Docket Item # 14
BAR CASE # 2007-0087

BAR Meeting
June 18, 2007

ISSUE: Alterations
APPLICANT: Ray Lewis, Lewis & Associates
LOCATION: 923 King Street
ZONE: KR/King Street Retail

PROPOSED WEST ELEVATION

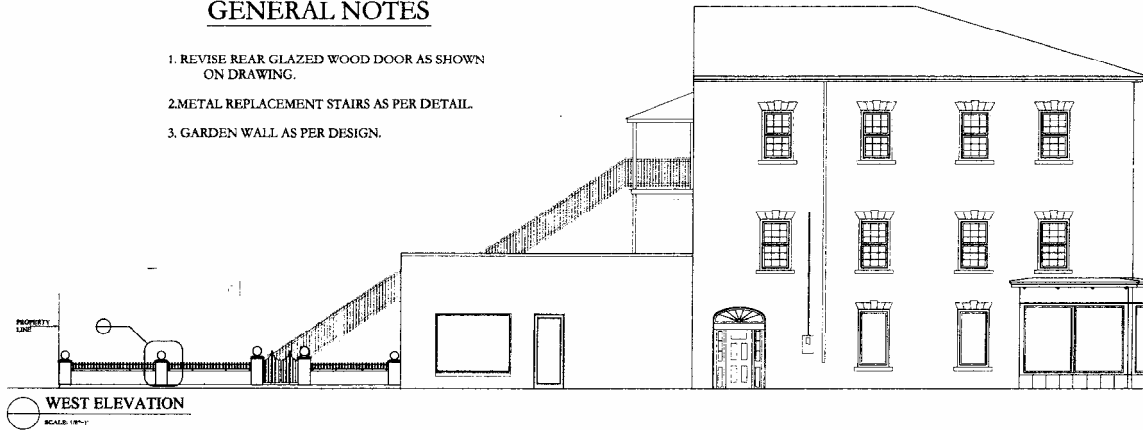
Staff supports the change in the new wood door on the rear addition.

GARDEN WALL DETAIL
 SCALE: 3/4\"/>

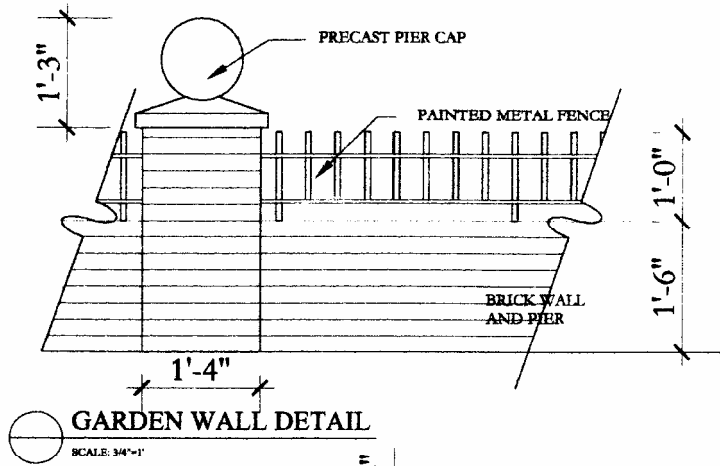
In general, Staff is supportive of the proposed alterations and believe they meet the Design Guidelines, and will enhance the appearance of this highly visible building at the corner of King Street and North Patrick Street. The proposed garden wall is appropriate in design and scale, and will provide a cleaner definition to the property. Staff would like the opportunity to review and

approve the color and type of brick used for the new wall prior to the issuance of the building permit. Staff would also recommend that the metal component be black.

1. That Staff review and approved the type of brick to be used on the garden wall prior to the issuance of the building permit;
2. That the metal on the garden wall be painted black; and,
3. That the metal replacement stairs be painted black.

○ TREAD RISER DETAIL

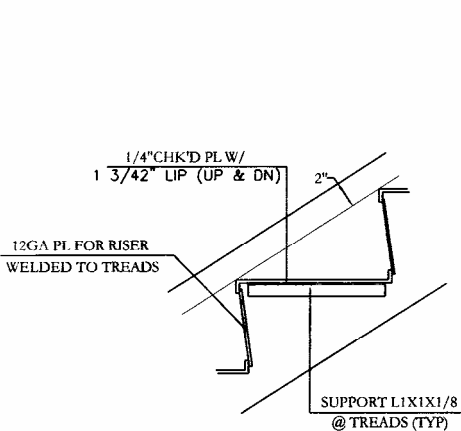
In respect to the replacement egress stairs, Staff believes that they will be an improvement over the existing wood stairs, but would like to ensure that the color of the metal complements the building. Staff would recommend the metal stairs be painted black.

- C-7 Stairs must comply with USBC. Stairways of 3 or more risers require handrails.
- C-8 The new stairs must comply with USBC for riser and tread dimensions.
